**Applicant's Supplemental Response #2 to CEC Staff
Data Request Set 1A
(Nos. 5, 8, 15, 16, 22, 43, 55, and 57)
for the APPLICATION FOR CERTIFICATION
for the Rio Mesa Solar Electric Generating Facility
(Rio Mesa SEGF)
(11-AFC-04)**

Subject: Supplemental Response #2 to CEC Staff Data Request Set 1A (#s 5, 8, 15, 16, 22, 43, 55, and 57) Rio Mesa Solar Electric Generating Facility (11-AFC-04)

Figure 2-9 a through d
Boiler Optimization Elevation Drawings

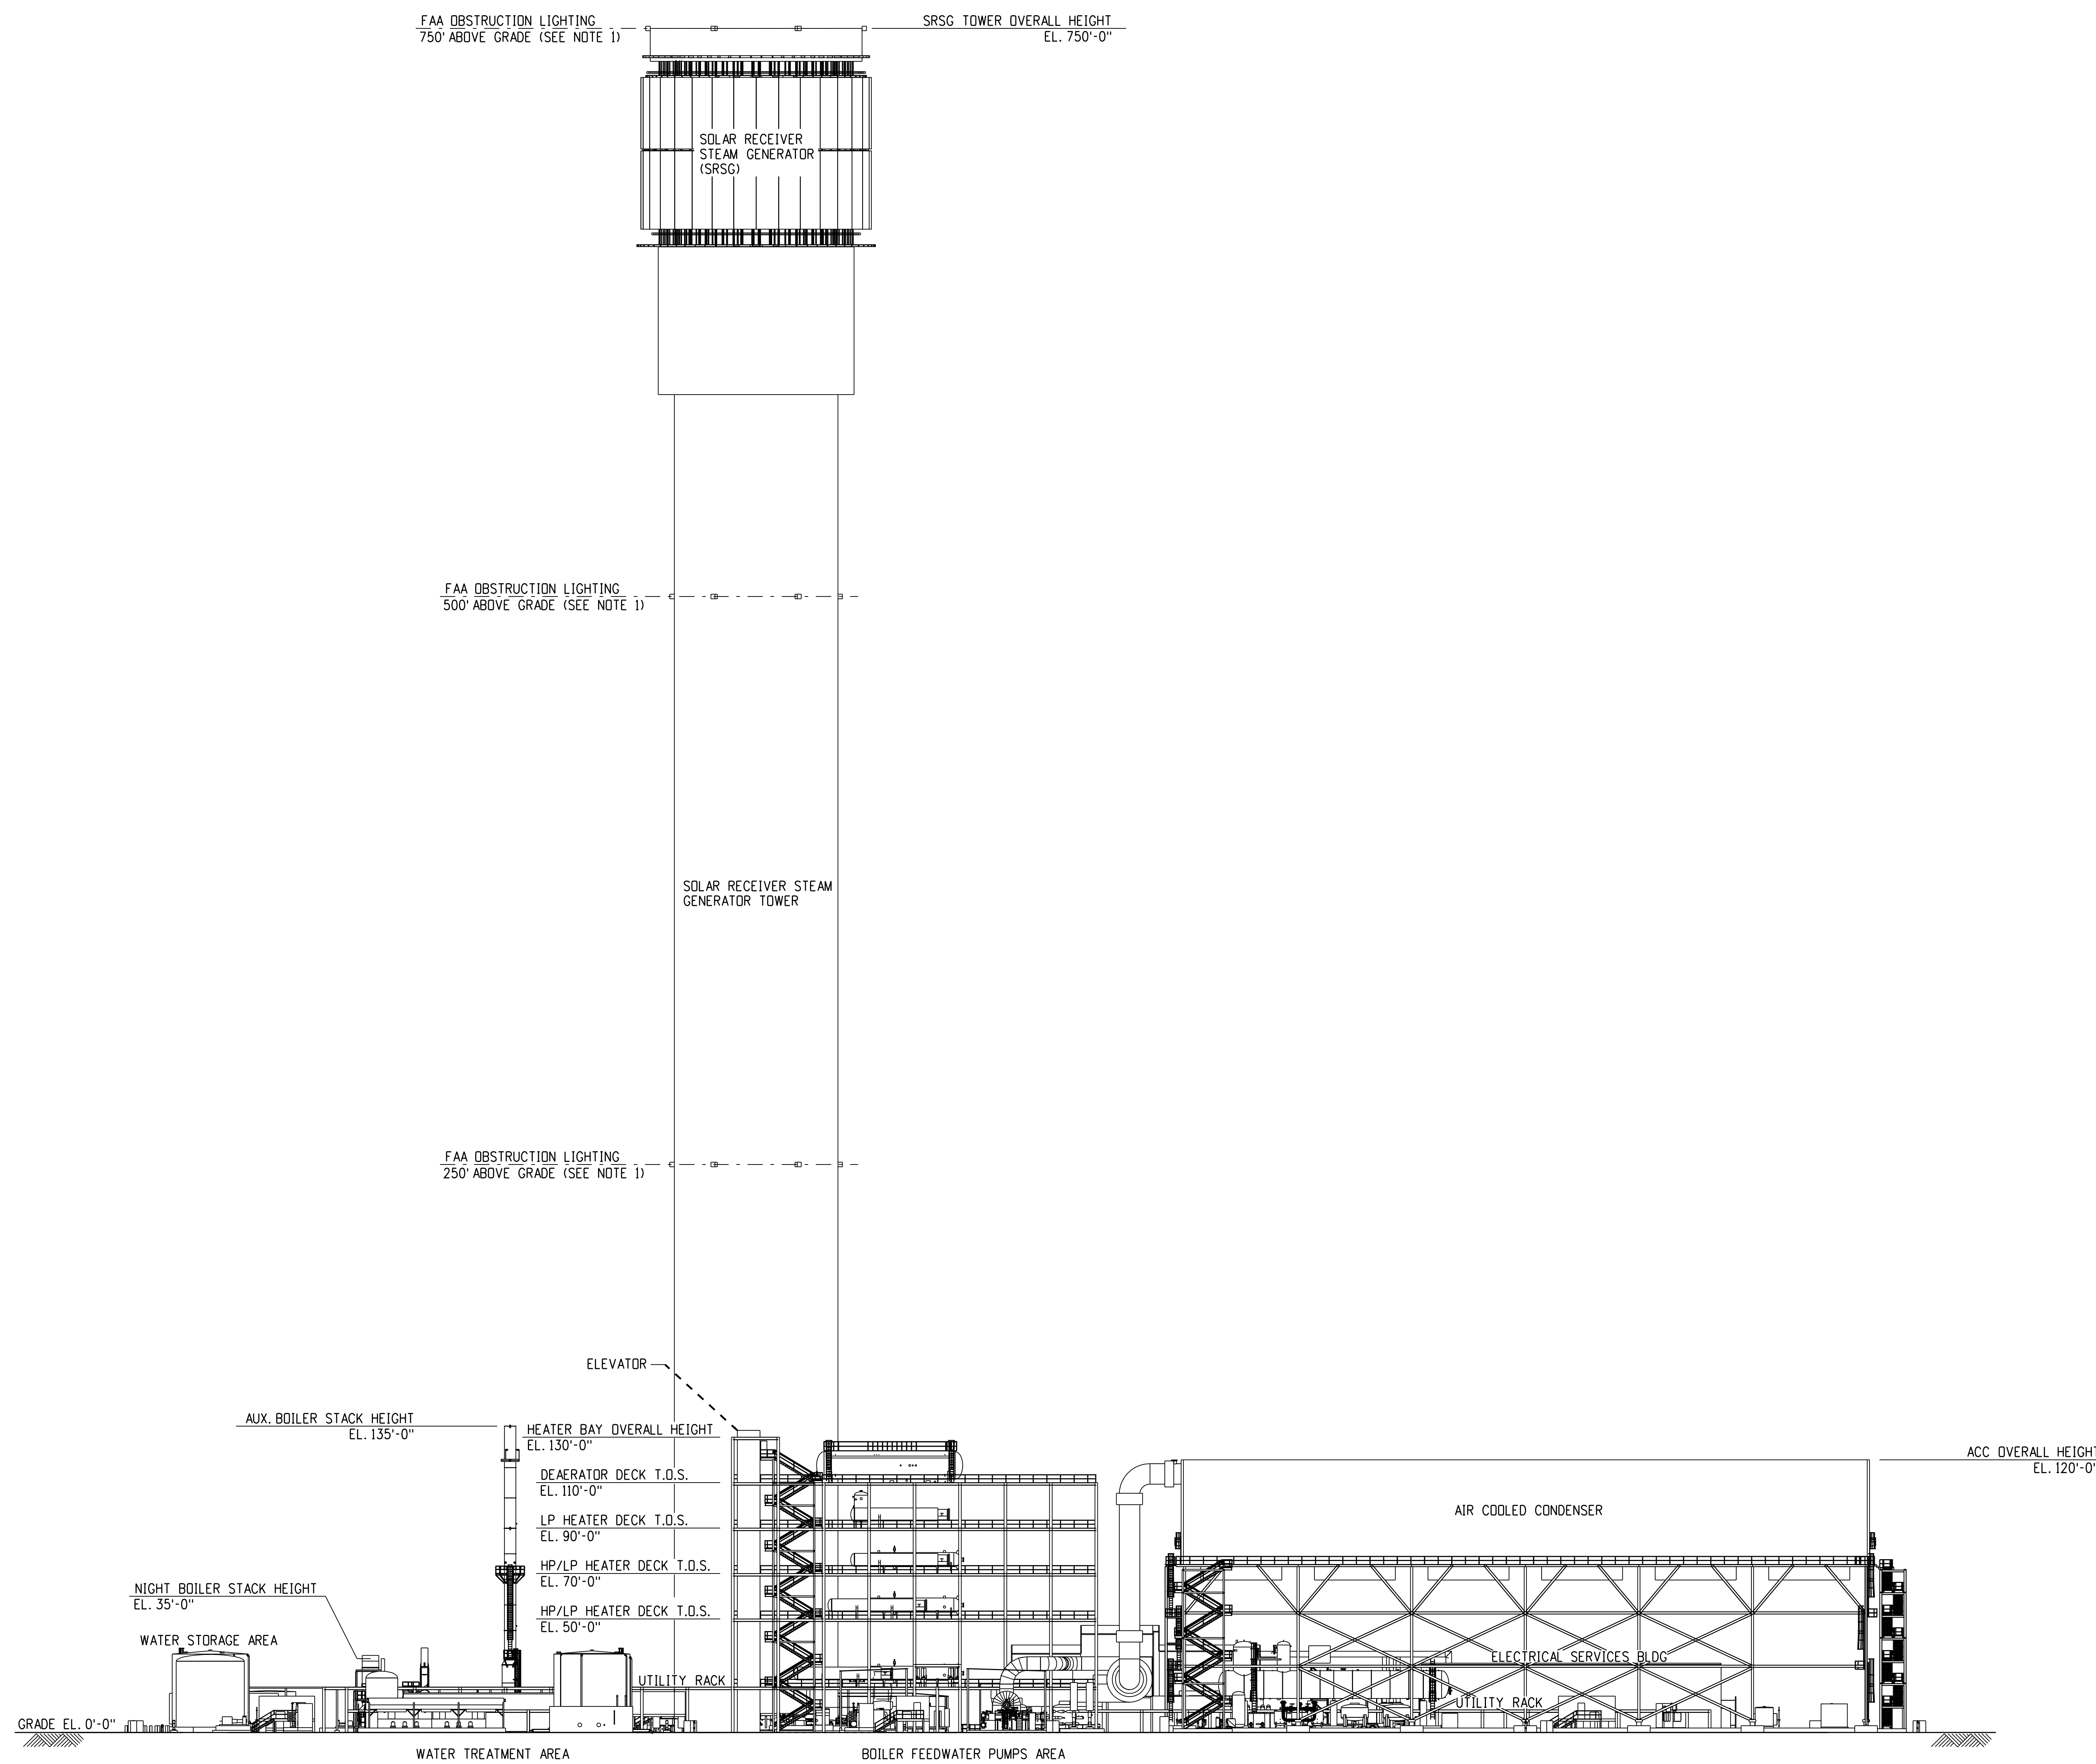
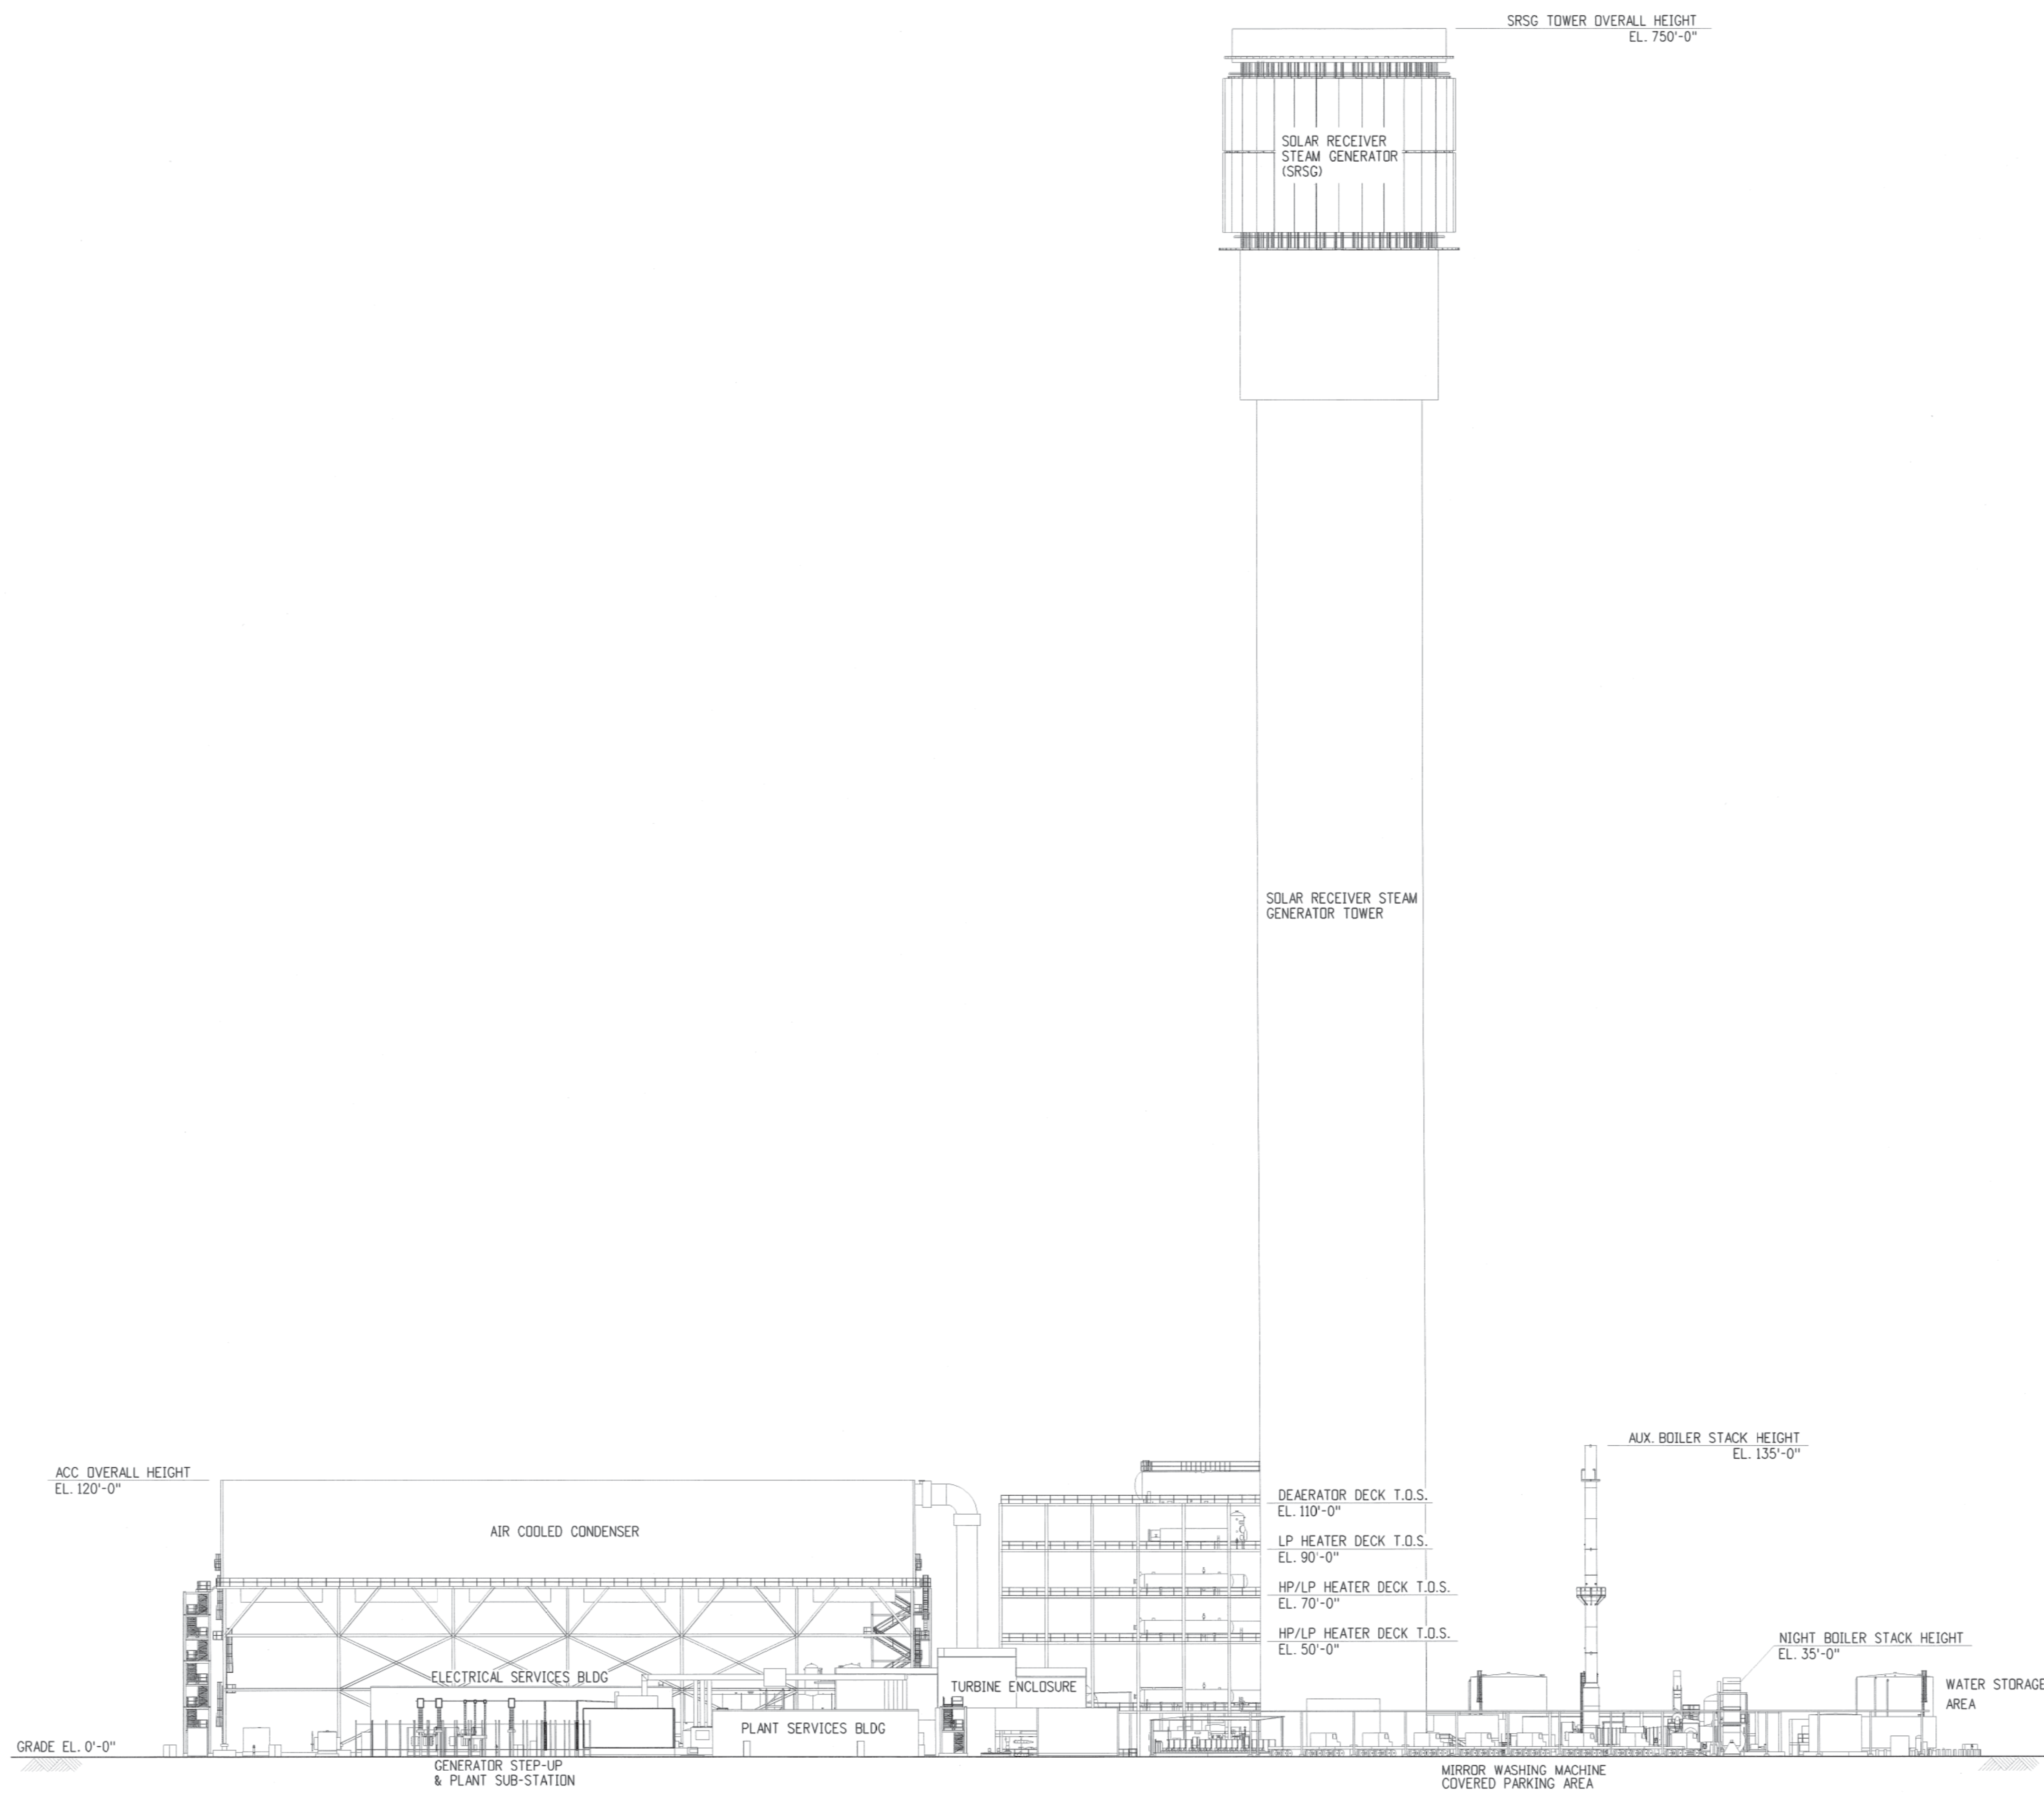
The Boiler Optimization reduces the number of boilers at each power block from five to two. The three, large auxiliary boilers will be eliminated, while the medium-sized and smallest boilers will remain. The operation of the remaining boilers will be modified to support the operation of the solar receiver steam generating system (SRSG) in a more efficient and effective manner.

of the power block has been revised. Figures 2-3-R1, 2-5-R1, and 2-8-R1 show the updated plot plan. In addition, Figures 2-9 a through d provide Boiler Optimization elevation drawings.
